**CEDAR KEY WATER AND SEWER DISTRICT**  
**INVITATION TO BID NO: 2025-01**  
**LIFT STATION REHABILITATION – PHASE II**  
**ADDENDUM NO. 5**

**January 27, 2026**

**CEDAR KEY**  
**SANITARY SEWER**  
**LIFT STATION**  
**REHABILITATION-PHASE II**

**M-902**

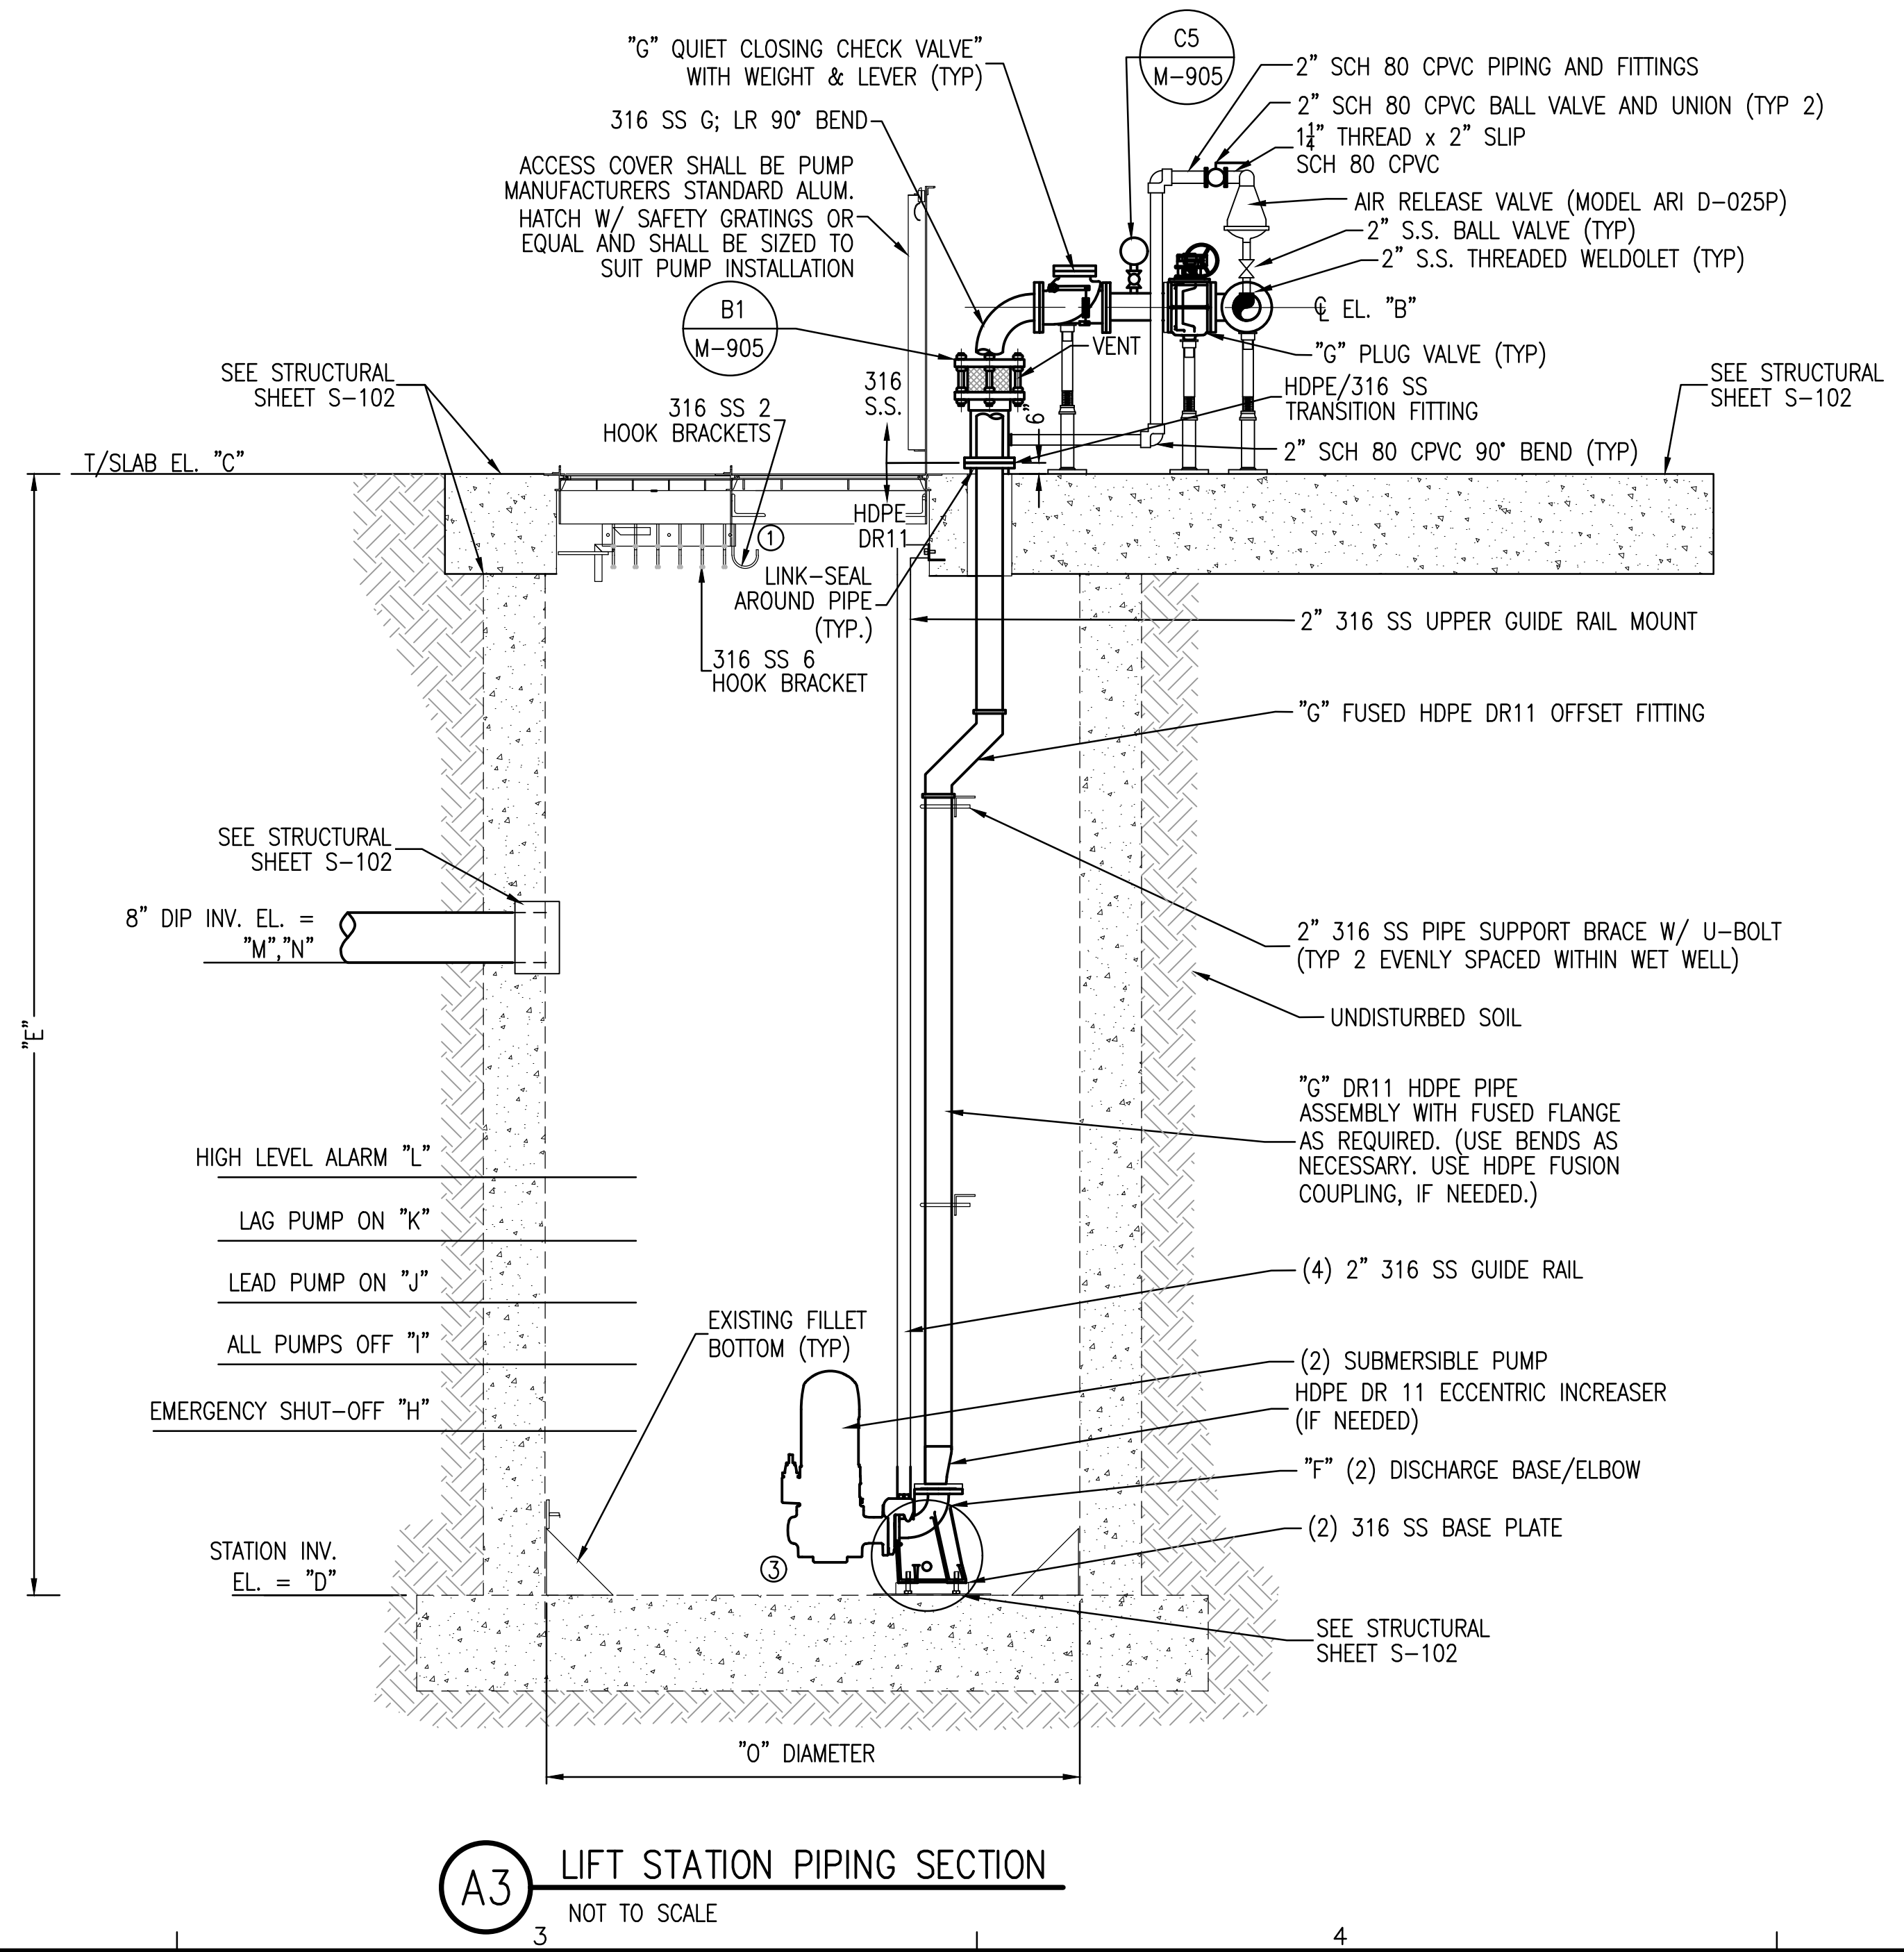
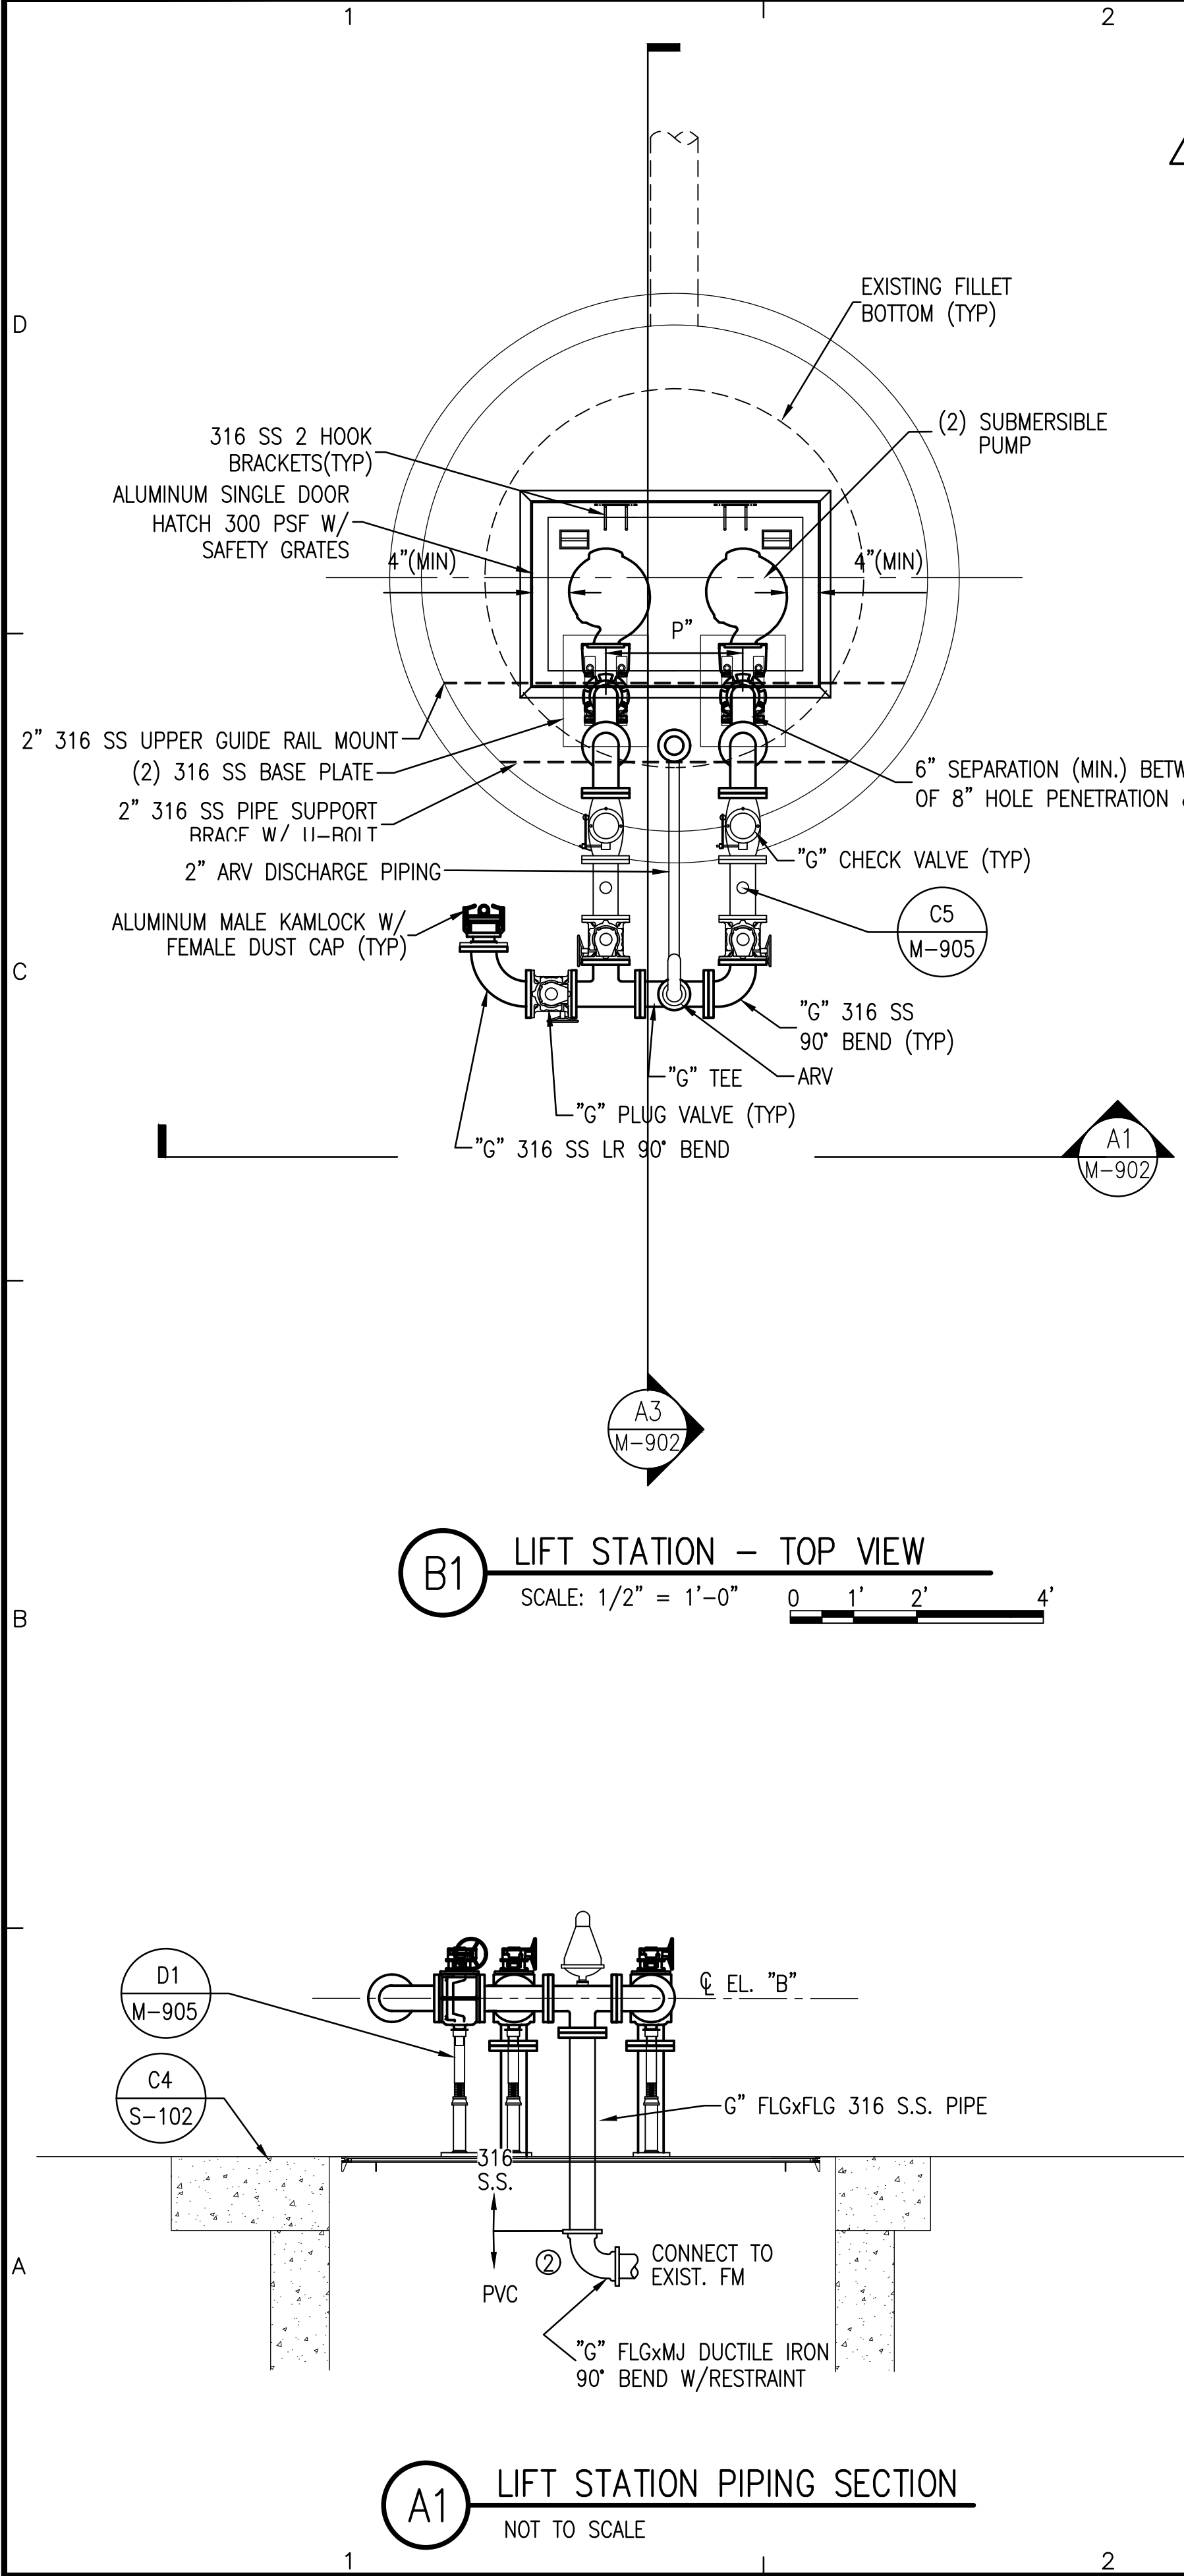
ITEM	DRAWING SHEET	CHANGE
1.	M-902 (REVISED SHEET)	The Pump Station Improvement Schedule was updated accordingly to reflect the adjusted operating conditions and float elevations.
2.	M-903 (REVISED SHEET)	The Pump Station Improvement Schedule was updated accordingly to reflect the adjusted operating conditions and float elevations.
4.	M-904 (REVISED SHEET)	The revise drawing sheets includes the updated discharge piping CL elevation and fillets required around the bottom of the fiberglass wet well basin per FDEP requirements.

DESCRIPTION	GPM	TDH	"A" (HP)	"B"	"C"	"D"	"E"	"F"	"G"	"H"	"I"	"J"	"K"	"L"	"M"	"N"	"O"	"P"	REMARKS
P S No. 3	198	28	3	7.42	± 4.92	± -5.26	± 10'-2"	4"	4"	-3.54	-2.33	-1.08	-0.08	-	-	± -1.36	5'-0"	26"(MIN)	
P S No. 4	84	24.5	3	6.93	± 4.43	± -7.23	± 11'-8"	4"	4"	-5.51	-4.30	-2.90	-2.40	-	-	± -3.09	5'-0"	26"(MIN)	
P S No. 5	112	22	3	6.96	± 4.46	± -7.92	± 12'-5"	4"	4"	-6.20	-4.99	-3.59	-3.25	-	-	± -2.16	5'-0"	26"(MIN)	
P S No. 15	137	39.9	5	7.65	± 5.15	± -8.71	± 13'-10"	4"	4"	-6.99	-5.82	-3.82	-3.32	-3.24	-	± -3.23	5'-0"	26"(MIN)	
P S No. 16	115	34.8	5	7.34	± 4.84	± -7.23	± 12'-1"	4"	4"	-5.51	-4.34	-2.39	-1.89	-	± -2.72	± -2.78	5'-0"	26"(MIN)
